Topic: Water Coolers, Version 3.0 Specification, Draft 2

This letter comprises the comments of the Pacific Gas and Electric Company (PG&E), San Diego Gas and Electric (SDG&E), and Southern California Edison (SCE) in response to the United States (U.S.) Environmental Protection Agency (EPA) Version 3.0 Draft 2 Water Coolers Specification.

Figure 1: Hot and cold capacity per hour of freestanding, air-cooled, bottle-type water dispensers in CEC MAEDbS dataset, by unit ID number.

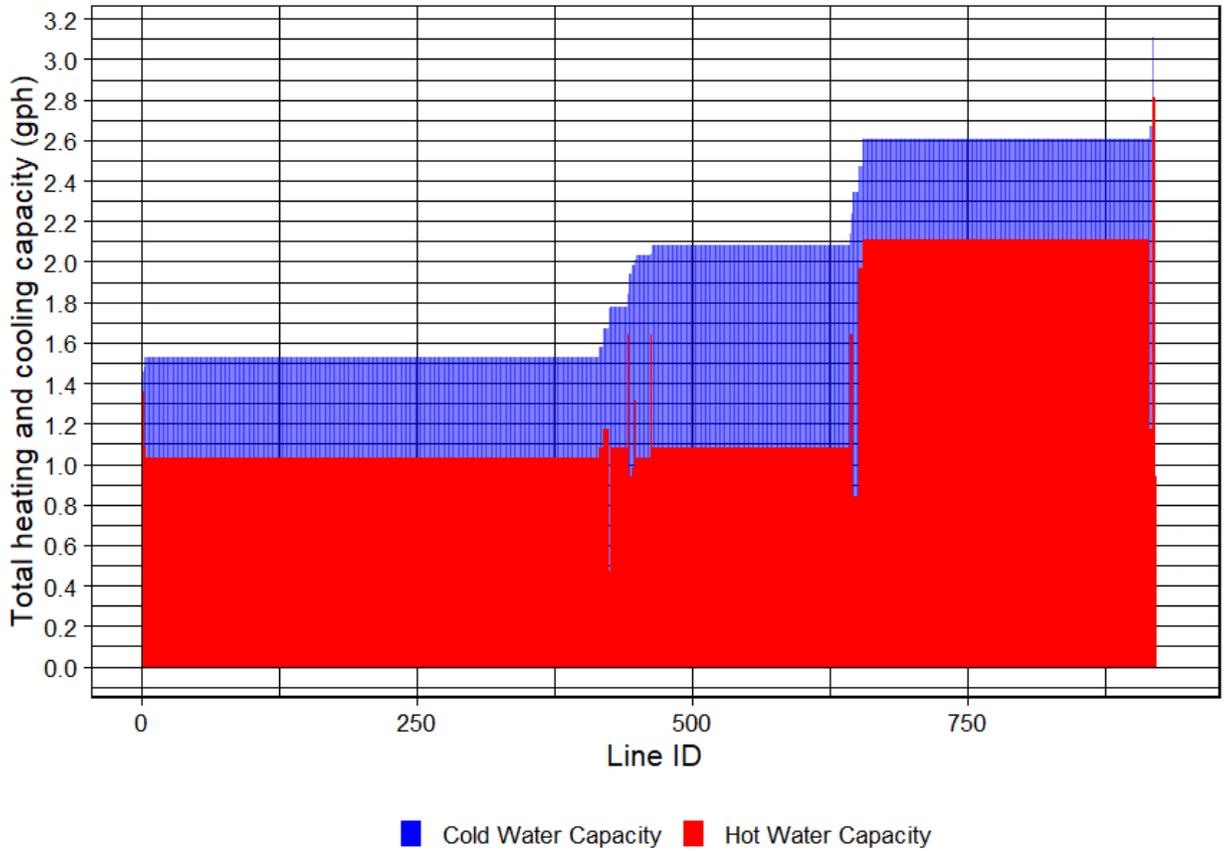
Further inspection of this data demonstrates an underlying reason few units reach the high capacity threshold: most units in this dataset with higher cooling capacity opt for smaller hot water capacity, and vice versa. See Figure 1 for this dataset sorted by ascending total capacity. We note that the most common cold water capacity is approximately 0.5 gph, with 1.0 gph for increased cold water capacity units. Similarly, hot water units are typically 22-23 six oz cups (approximately 1.0 gph), with increased hot water capacity units typically at or above the 45 6-oz cup threshold. This is supportive of both proposed high capacity definitions, as (1) hot water capacity is confirmed to be designed around 45 six oz cups of hot water, and (2) 0.61 gph is a cut point for cold water capacity, which successfully separates low and high capacity cooling units.

On this topic, we encourage EPA to include additional supporting data on why 0.61 gph exactly is the proposed cut-point. In the webinar, EPA noted this cut-point was suggested by manufacturers, and we encourage EPA to document the underlying properties of the cold water cooler system that lead to this cut point over more simple limits such as 0.6 gph. Further, the EPA definition for low capacity water coolers should be amended to read “A water cooler with a cold-water dispenser capacity of less than 0.61 gph,” to obtain the intended product group.
